Abingdon Town Council Planning Inspectorate Thames Water SESRO EIA Scoping response

Scoping Comments

1. EIA Assessment area boundaries – Fig 1.2

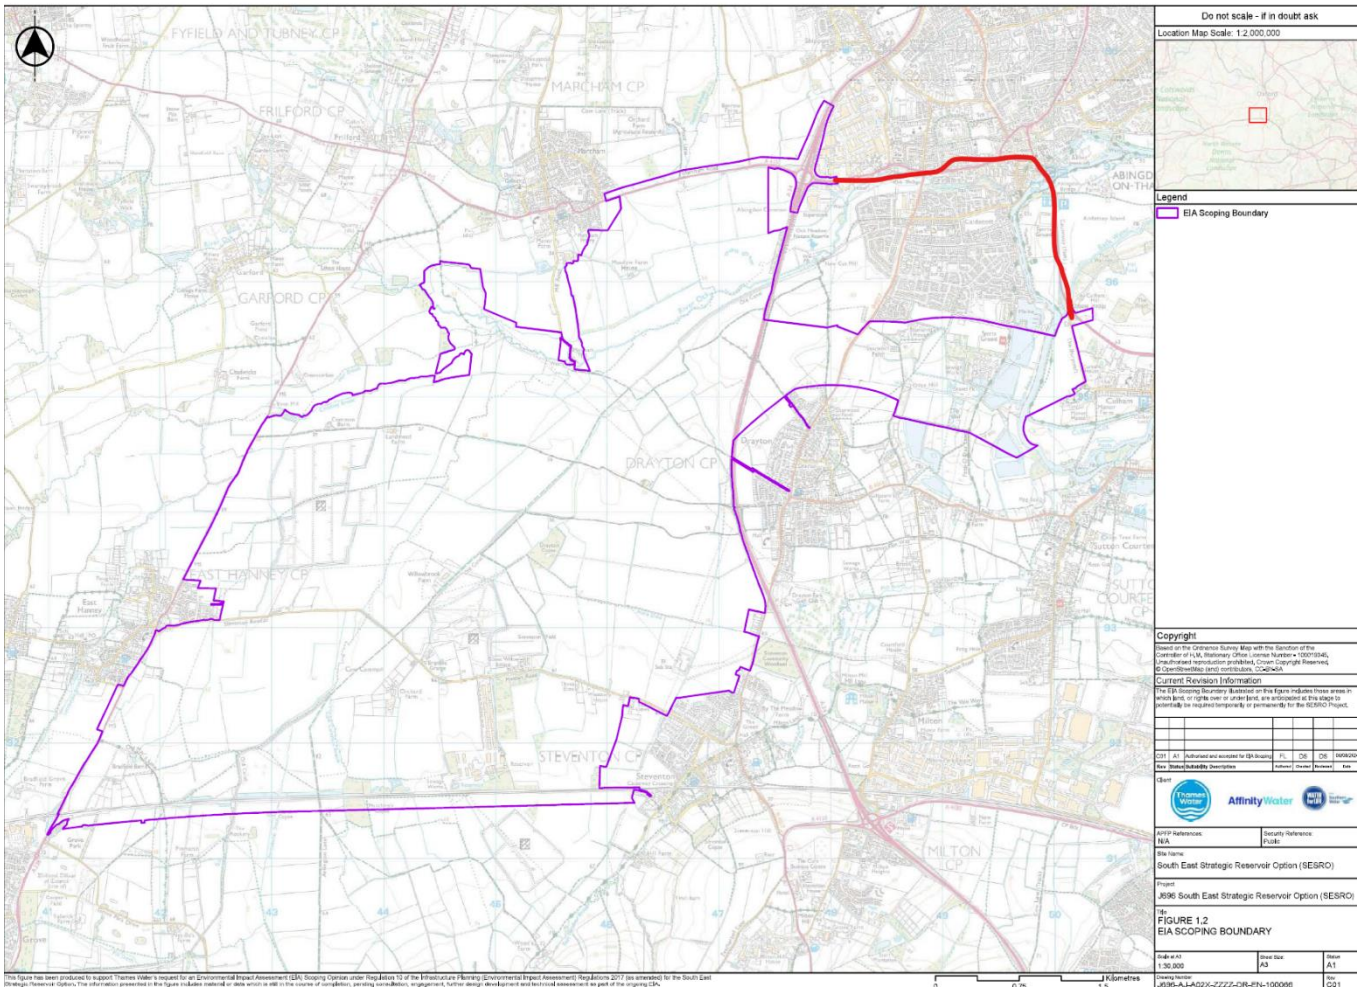
Abingdon Town Council has an issue with these boundaries as the areas of south Abingdon, in particular the River Ock floodplain from the A34 culvert, continuing in close proximity or through residential areas that have in the past been affected by flooding, to the confluence of the Ock and the Thames.

In the Council’s opinion this area should be scoped into the assessments as the S19 Flood Incident Report referred to in point 4 occurred within that area and we have concerns that SESRO will cause additional water course and groundwater flooding in this well-populated area.

Our scoping would follow Marcham Road, Ock Street and the High Street to the North and Bridge Street to the East as shown:

4. River Ock flood area – Chapter 6.6.31 statement and see Town Council amended boundaries plan

- These areas of Abingdon require scoping into the EIA.
- Currently, Thames Water say they have limited groundwater data for River Ock area, more modelling and data is needed, but our fear is SESRO occupying this location will increase flood risks for the town and surrounding areas.
